In Support of Test Fixtures Comments

IEEE 802.3ck Taskforce Meeting
Geneva

Jan 20, 2020

CL120F Informative Insertion Loss (Comment 177)

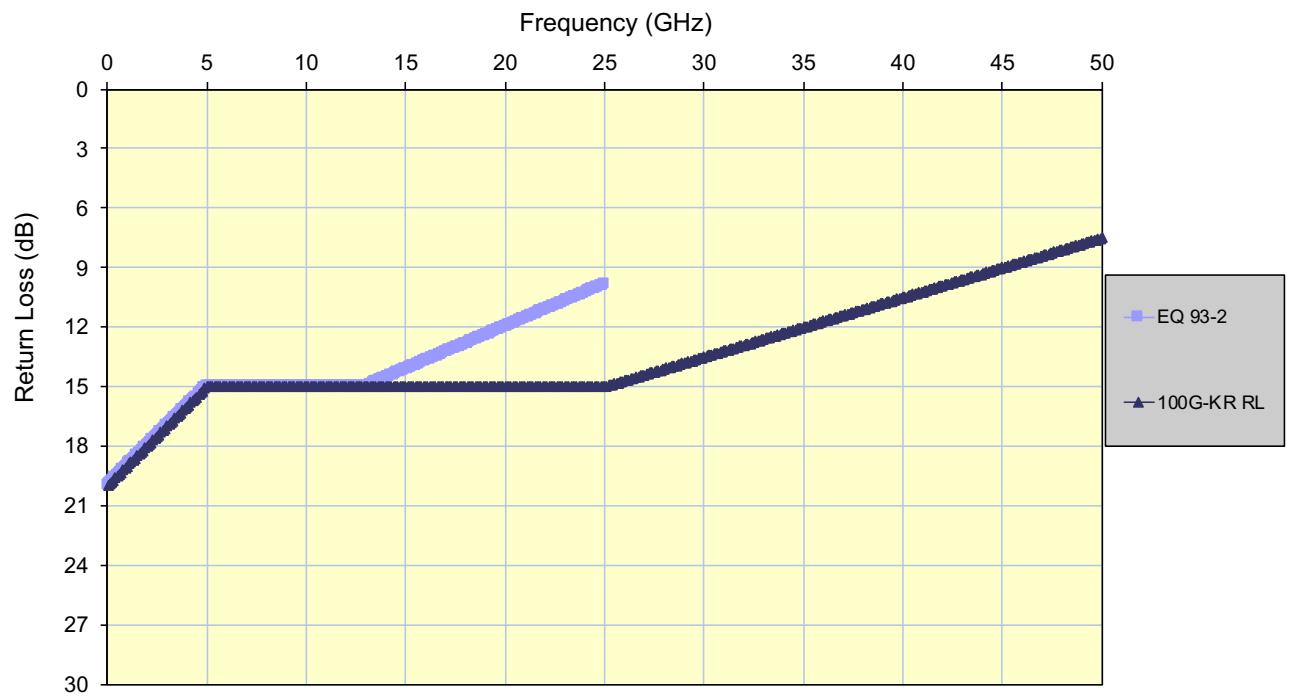
- CL120F informative insertion loss scaled from CL120D both with 20 dB loss at Nyquist.

$$\text{Insertion_Loss}(f) = 1.083 + 1.25\sqrt{f} + 0.47f \quad 0.01 \leq f \leq 50 \text{ GHz}$$

Update to KR Test Fixture IL and RL (Comment 172, 173)

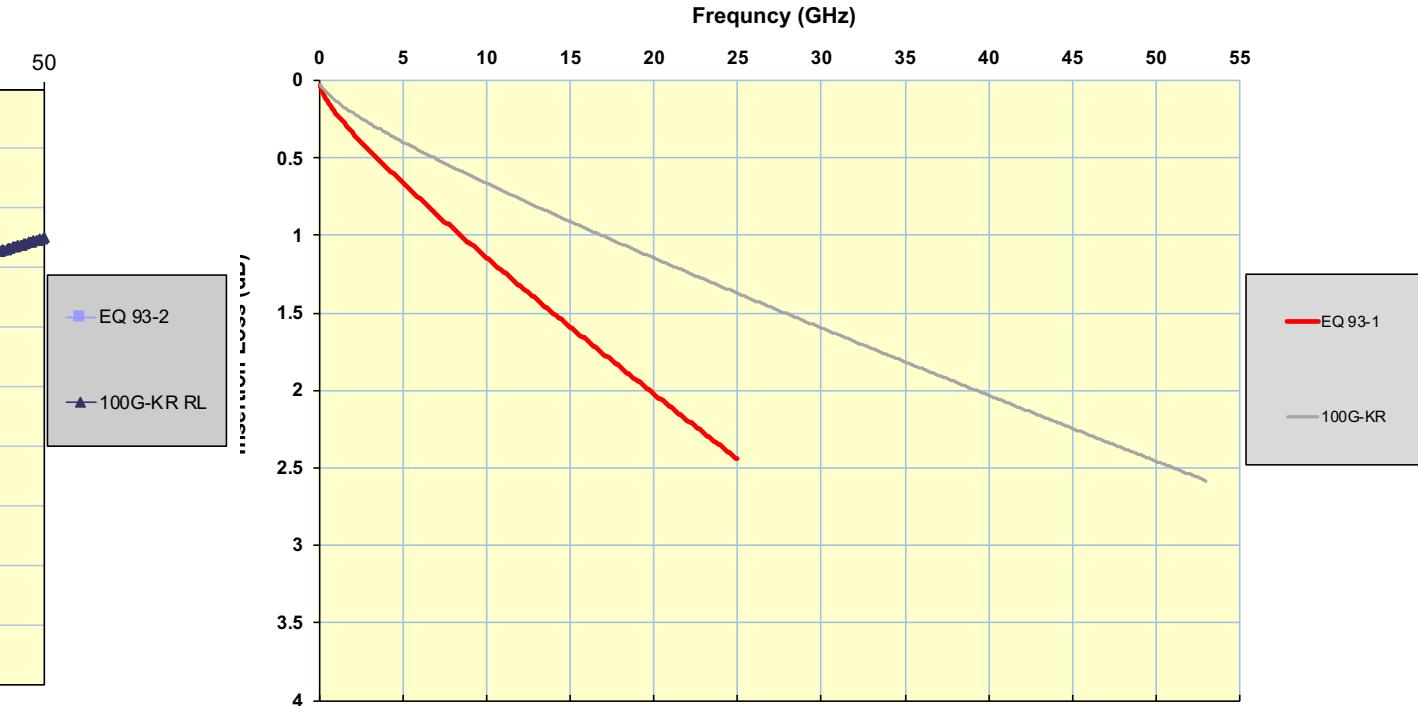
- RL scaled but IL max RL at 50 GHz reduced from 9.85 dB to 7.5 dB due to difficulty one would have meeting the RL at 50 GHz.**

$$RL_d(f) \geq \begin{cases} 20 - f \text{ dB} & 0.05 \leq f \leq 5 \text{ GHz} \\ 15 \text{ dB} & 5 < f \leq 25 \text{ GHz} \\ 22.5 - 0.3f \text{ dB}, & 25 < f \leq 50 \text{ GHz} \end{cases}$$

$$IL_{ref}(f) = -0.0015 + 0.1\sqrt{f} + 0.035f \quad 0.05 \leq f \leq 50 \text{ GHz}$$

Mated Board IL (Comment 185)

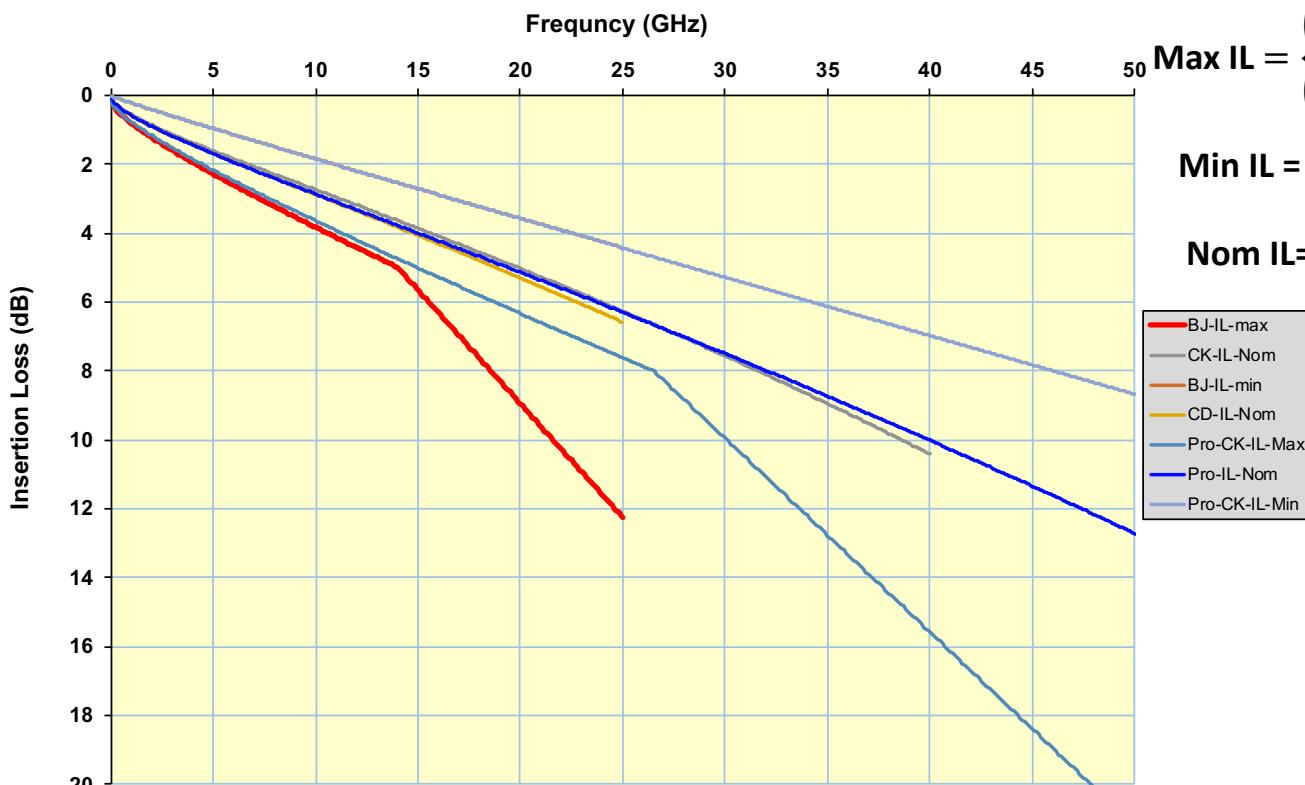
- ❑ Maintaining the current 6.6 dB loss at 26.55 GHz but adjusting f^2 factor slightly to remove curve past 30 GHz
 - Also providing min and max loss to replace TBDs
 - FOM ILD (max) <=0.1 dB over range of 0.01-40 GHz.

$$\text{Max IL} = \begin{cases} (0.12 + 0.475\sqrt{f} + 0.221f) \times 0.9503 \text{ dB } 0.01 \leq f \leq 26.55 \text{ GHz} \\ 6.9505 + 0.562f \quad 26.55 < f \leq 50 \text{ GHz} \end{cases}$$

$$\text{Min IL} = 0.0656\sqrt{f} + 0.164f$$

$$\text{Nom IL} = 0.9503 \times (0.471\sqrt{f} + 0.141f + 0.0012xf^2) \quad 0.05 \leq f \leq 50 \text{ GHz}$$

Mated Board SDD11/22 for Mated QSFP56 Test Board (Comment 188)

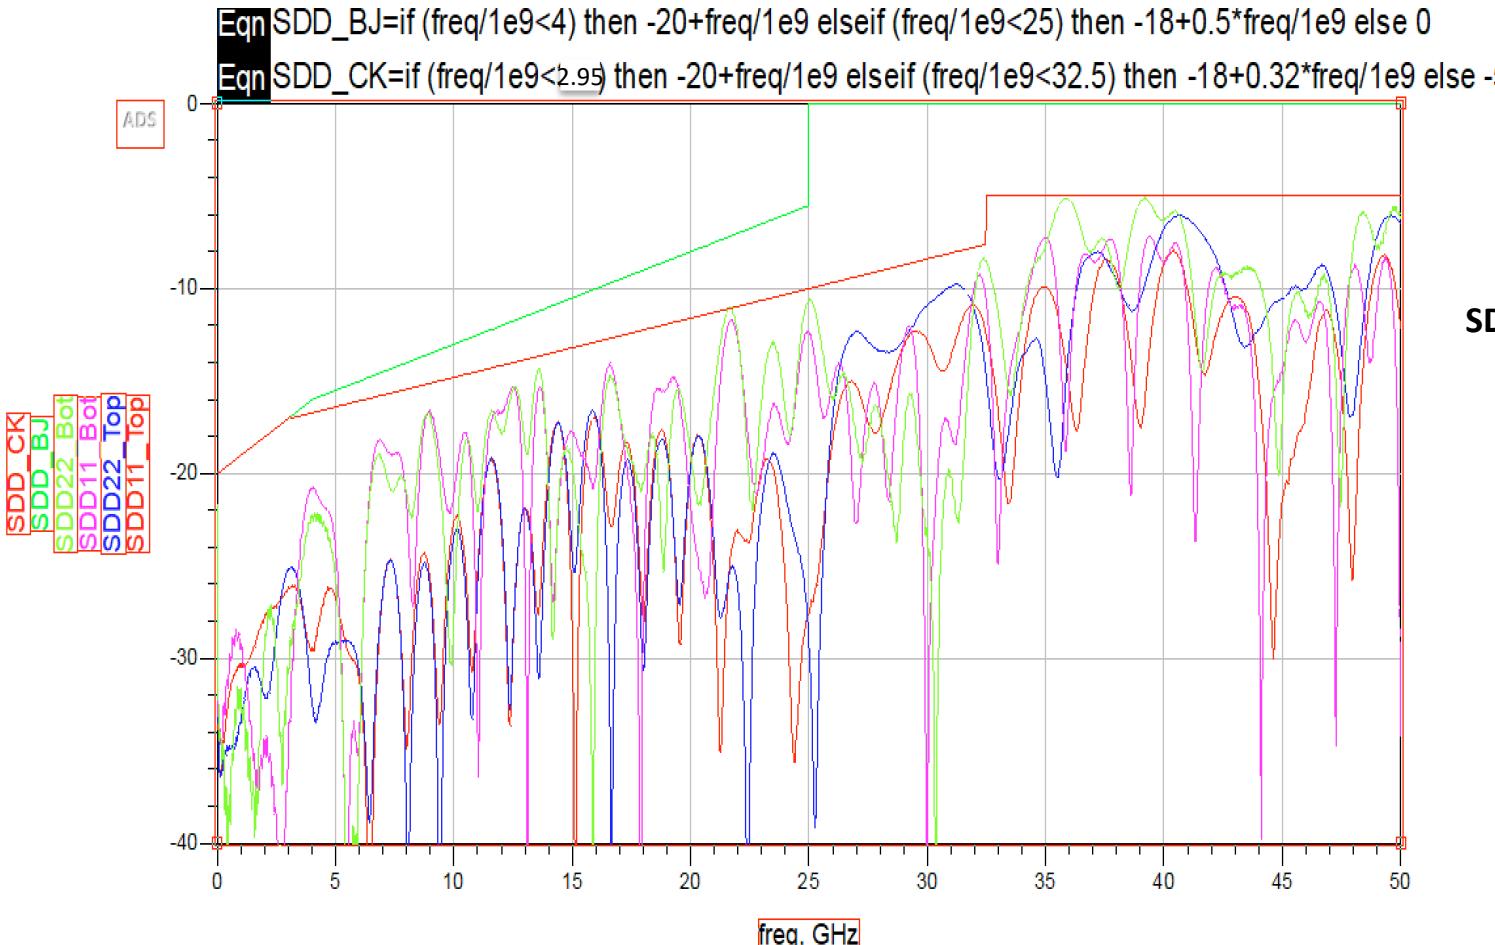
Proposed SDD extend the BJ SDD11/SDD22 masks

Mated QSFP56 Test Board SCC11/22

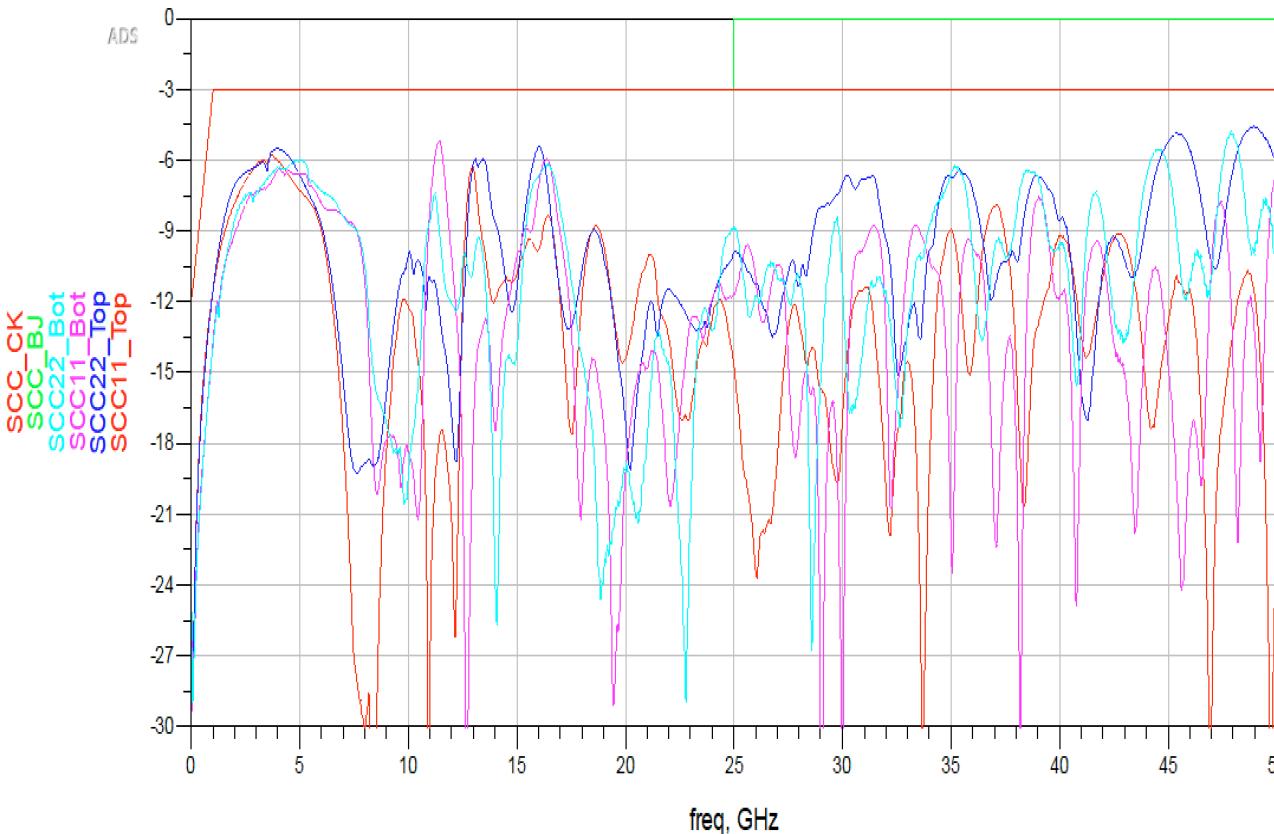
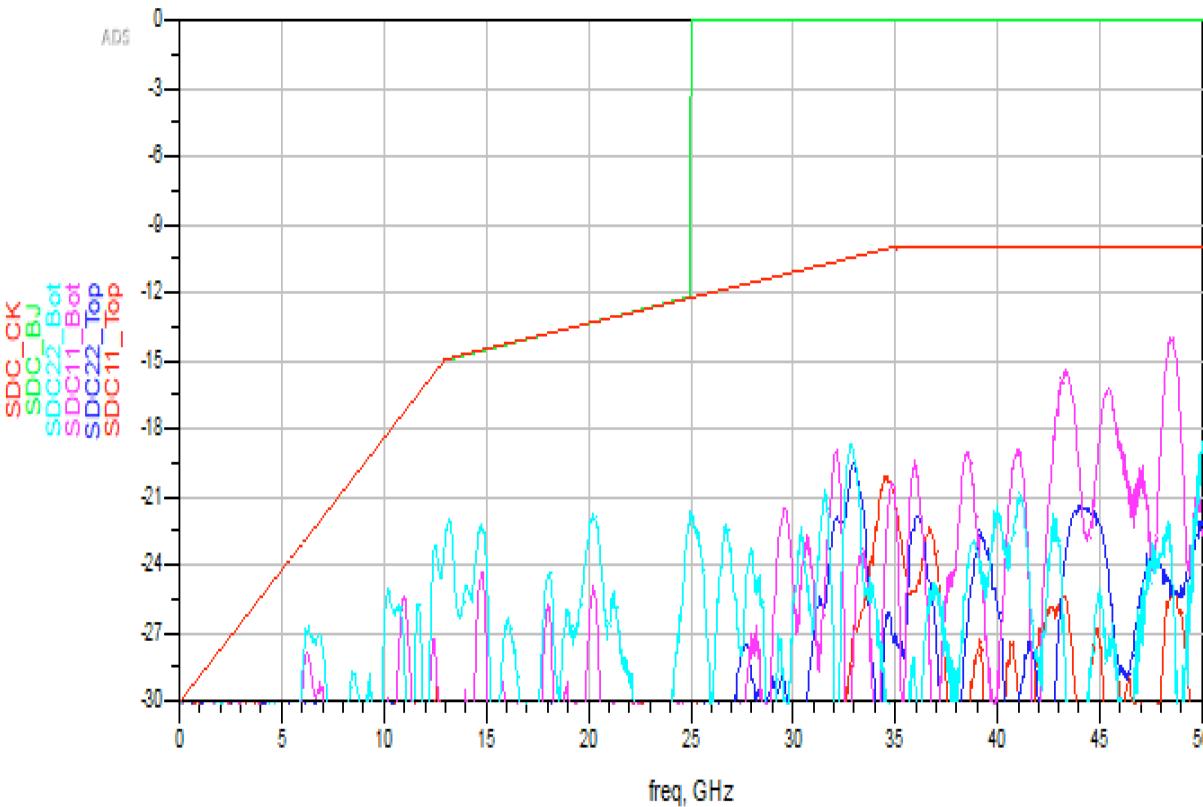
□ Proposed common mode RL extend the BJ SCC11/SCC22 masks

$$\text{SCCx RL} = \begin{cases} (20 - f) \times 0.9503 \text{ dB} & 0.01 \leq f \leq 2.95 \text{ GHz} \\ 18 - 0.32 \times f & 2.95 < f \leq 32.5 \text{ GHz} \\ 5 & 32.5 < f \leq 50 \text{ GHz} \end{cases}$$

Mated QSFP56 Test Board SDC11/22 (Comment 186)

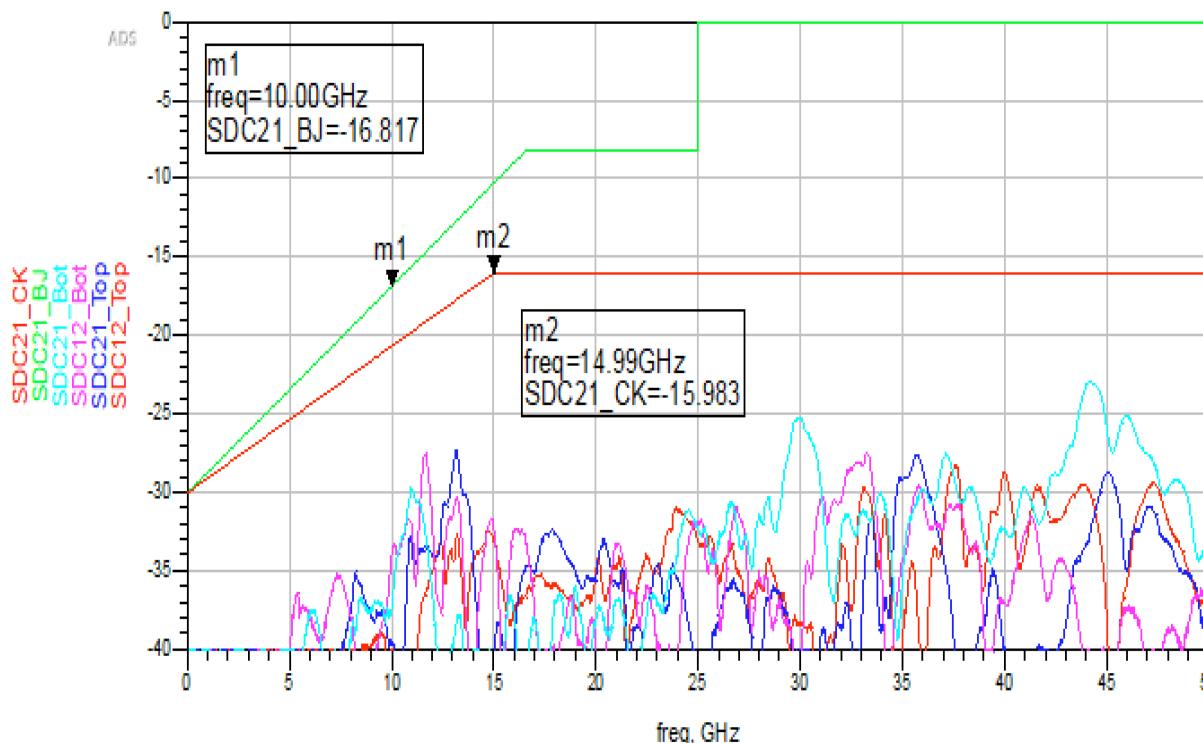
- Proposed common mode to differential extend the BJ SDC11/22 masks
 - Graph below shows S-parameters for RL invert the sign.

$$\text{SDDxx RL} = \begin{cases} 30 - 30 \times \frac{f}{25.78} \text{ dB} & 0.01 \leq f \leq 12.89 \text{ GHz} \\ 17.85 - 0.225 \times f & 12.89 < f \leq 35 \text{ GHz} \\ 10 & 35 < f \leq 50 \text{ GHz} \end{cases}$$
